Airworthiness Directive Issuance Form

民航局 AD 編號 AD number	CAA-2020-02-010	發布日期 Date issued	2020/2/21
適用之航空產品 Applied to (models, serial numbers or part numbers, as applicable)	Model MD-11 and MD-11F airplanes modified by supplemental type certificate (STC) ST01895WI. and Model 717-200 airplanes modified by STC ST04416AT. and All Model 737-8 and 737-9 airplanes. and All Model 737-600, -700, -700C, -800, -900, and -900ER series airplanes. and Model 747-400 and 747-400F series airplanes modified by STC ST01892WI. and Model 757-200, -200PF, -200CB, and -300 series airplanes modified by STC ST04436AT. and Model 767-200, -300, -300F, -400ER, and -2C series airplanes modified by STC ST04436AT or ST01883WI. and All Model 777-200, -200LR, -300, and -300ER series airplanes. and All Model 777F series airplanes.		
主旨摘要	This AD requires revising the existing airplane flight manual to include a limitation to prohibit operations that require less than 0.3 required navigational performance within a specified area for airplanes having a certain multi-mode receiver with certain software installed.

[Docket No. FAA-2020-0098; Product Identifier 2020-NM-011-AD; Amendment 39-19844; AD 2020-03-20]

Air

Figure 2 to paragraph (g) – AFM – Limitations or Certificate Limitations continued

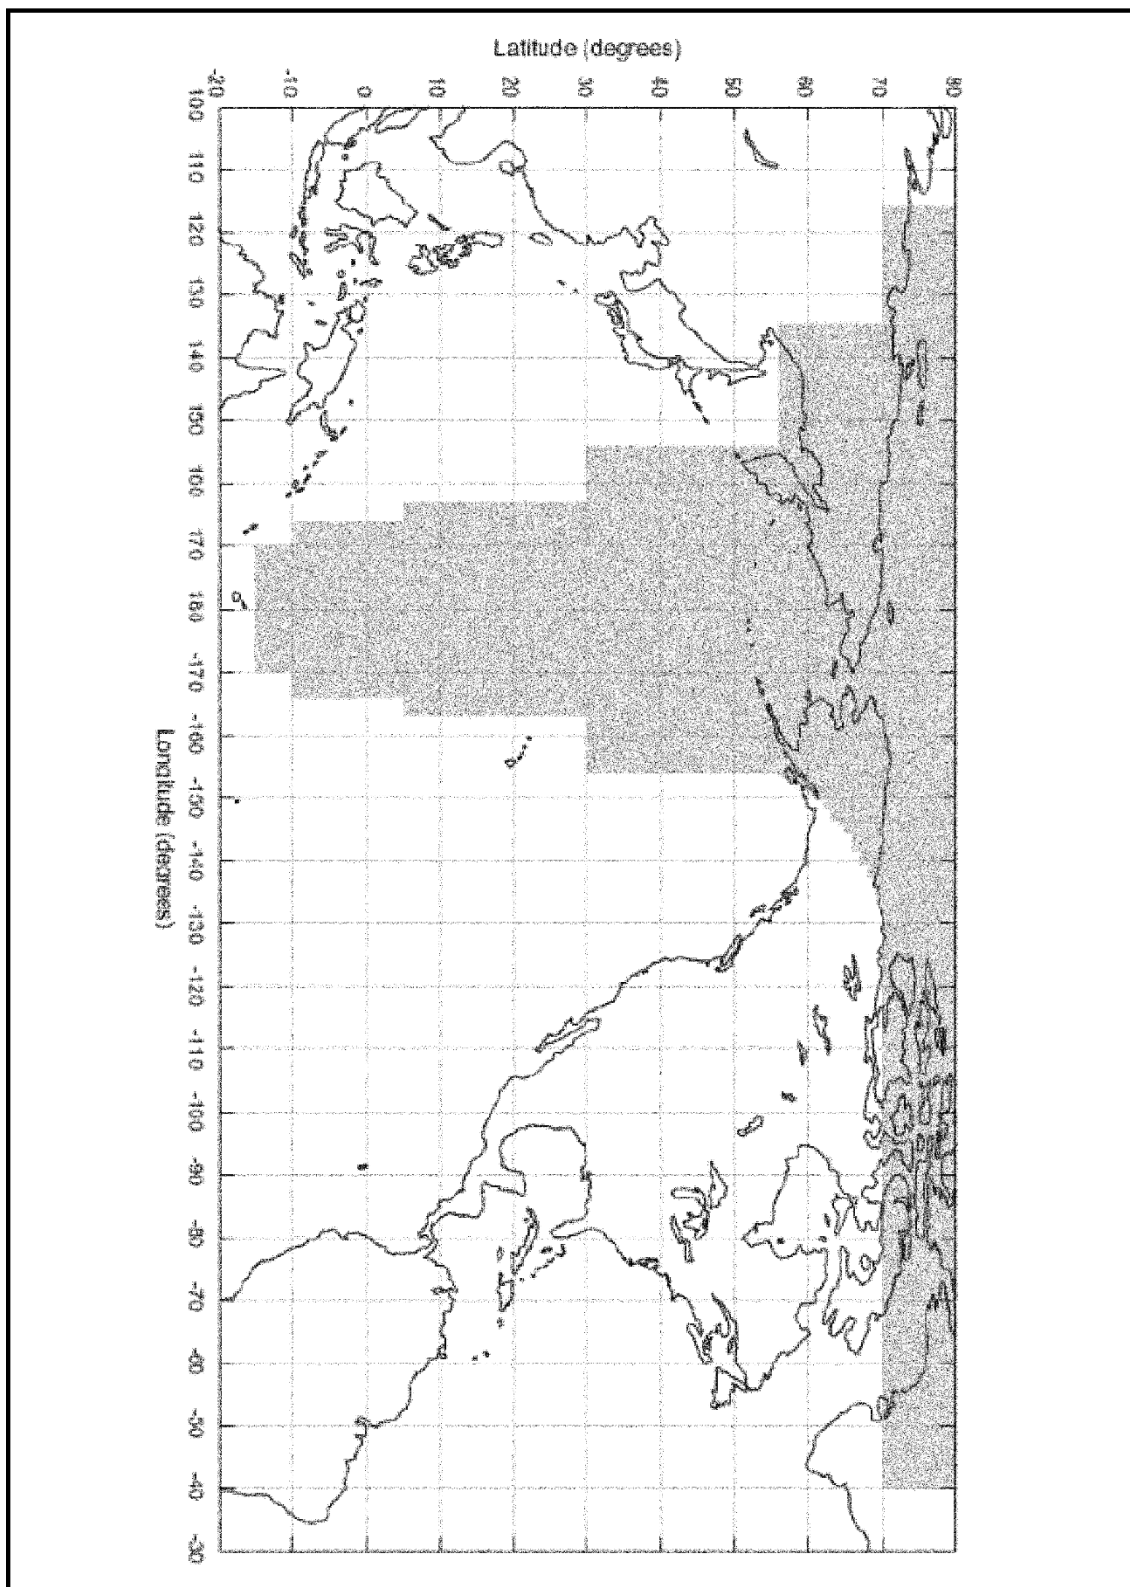
Operations that require less than 0.3 RNP (For example, 0.1, 0.11, 0.15, etc.) in the region identified below are prohibited with GLU-2100 OPS software number COL4D-0087-0002, COL4E-0087-0001, COL48-0087-0700, or COL49-0087-0701 installed.

Exception: Anchorage (PANC) approach procedures that allow less than RNP 0.3 are authorized provided the instructions outlined in the Electronics – Global Landing Unit Section of Normal Procedures Chapter are followed.

Note: Currently, Fairbanks (PAFA) and Anchorage (PANC) are the only airports in the region with an RNP approach that requires better than 0.3 nmi performance.

Region bounded by the following coordinates:

For airplanes equipped with Collins GLU-2100 MMR, part number (P/N) 822-2532-100, having any applicable GLU-2100 operational software (OPS) identified in figure 1 to paragraph (g) of this AD installed: At the applicable time specified in paragraphs (g)(1) and (2) of this AD, revise the limitations or certificate limitations section, as applicable, of the existing AFM to include the information specified in figure 2 to paragraph (g) of this AD and revise the procedures or normal procedures section, as applicable, of the existing AFM to include the information specified in figure 3 to paragraph (g) of this AD. This may be done by inserting a copy of figures 2 and 3 to paragraph (g) of this AD into the existing AFM.
